ATLANTIC PILOTAGE AUTHORITY

HERRING COVE BREAKWATER REPLACEMENT

CONTRACT NO. 190248.00

ADDENDUM NO. 1

DRAWING NAME: HERRING COVE BREAKWATER REPLACEMENT\00 CAD\03 STRUCT\190248.00 - S01.DWG LAYOUT NAME: S01 DDATE: FEBRUARY 27, 2020 8:55:36 AM CAD OPERATOR: MCKENZIE

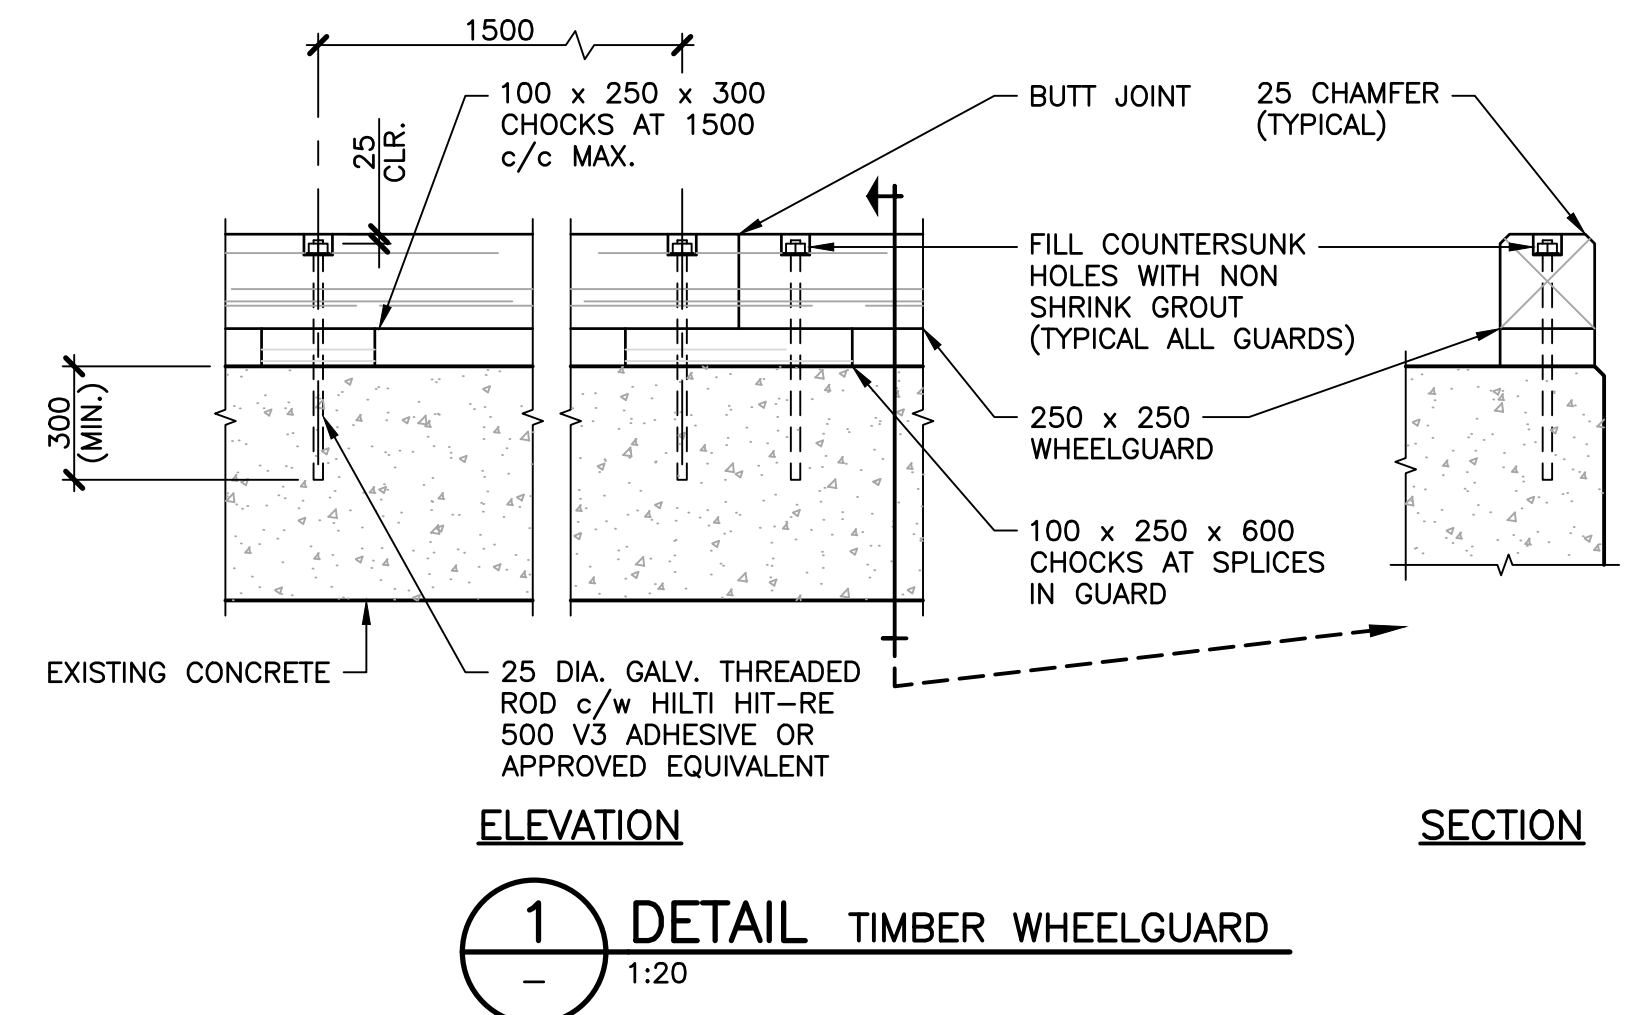
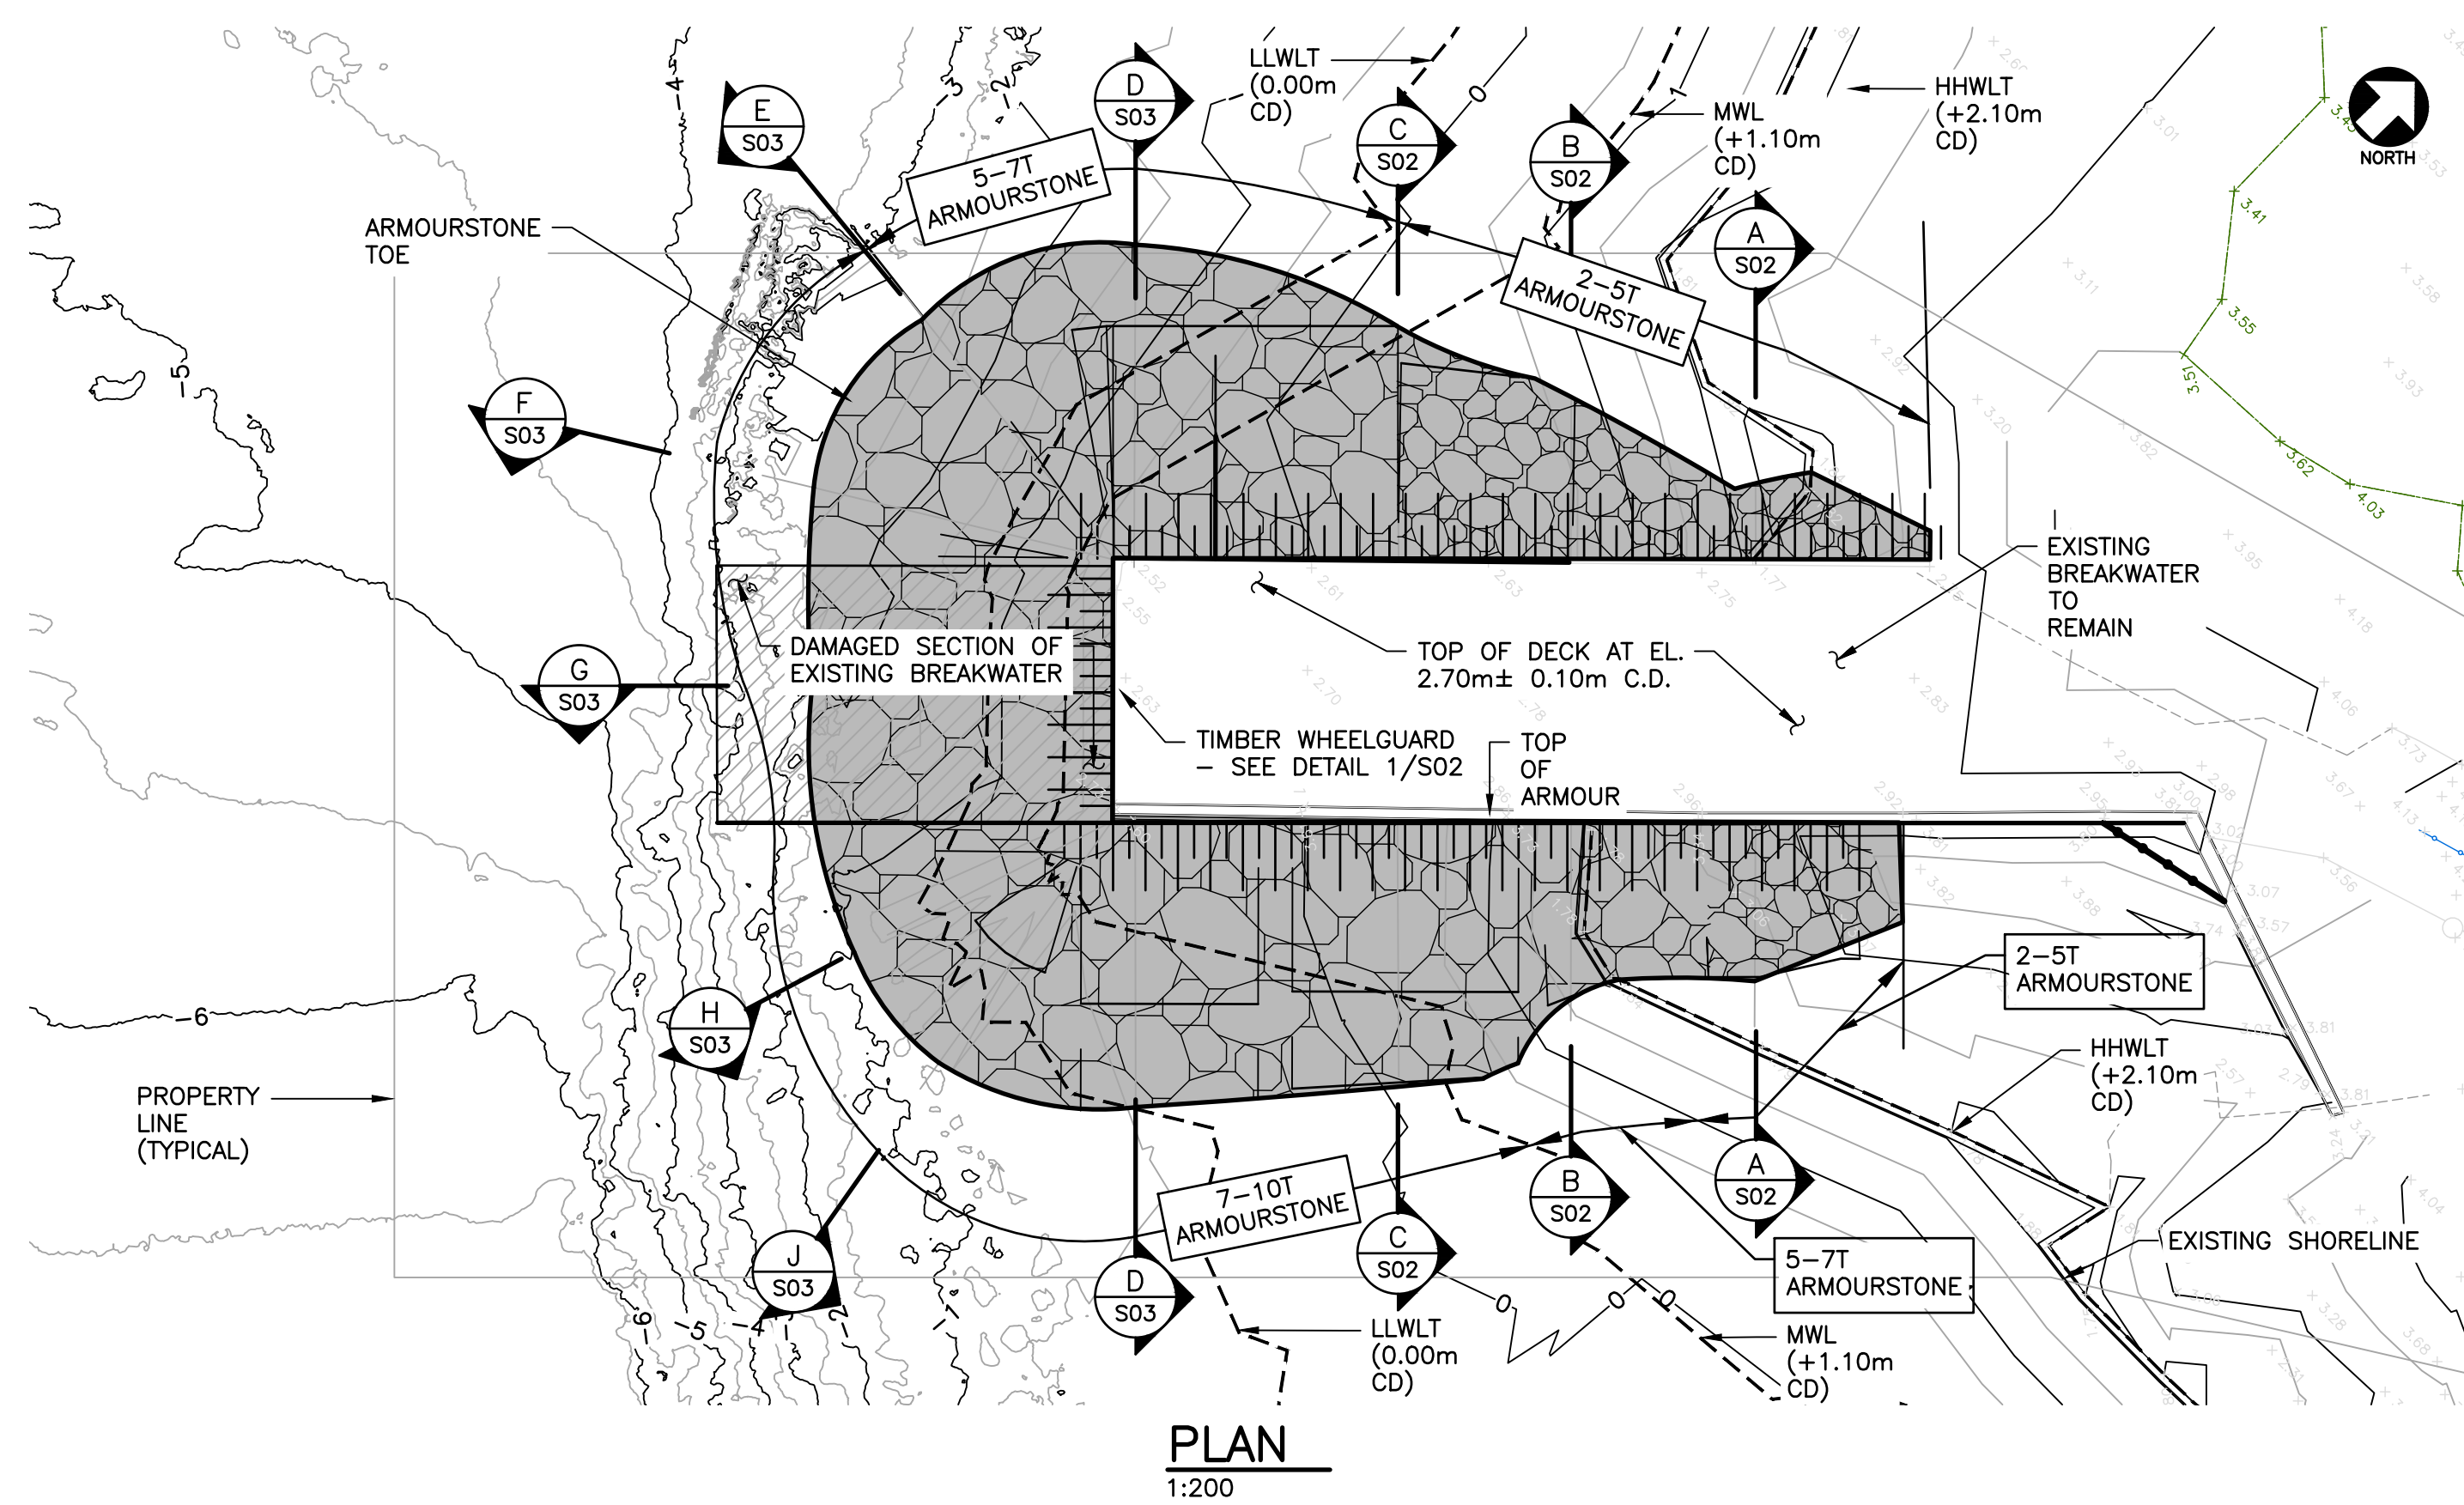
Replace with attached Drawing S02 – NEW BREAKWATER PLAN AND SECTION, elevation marks added to plan contours, Re-Issued for Tender, dated Feb. 28/20.
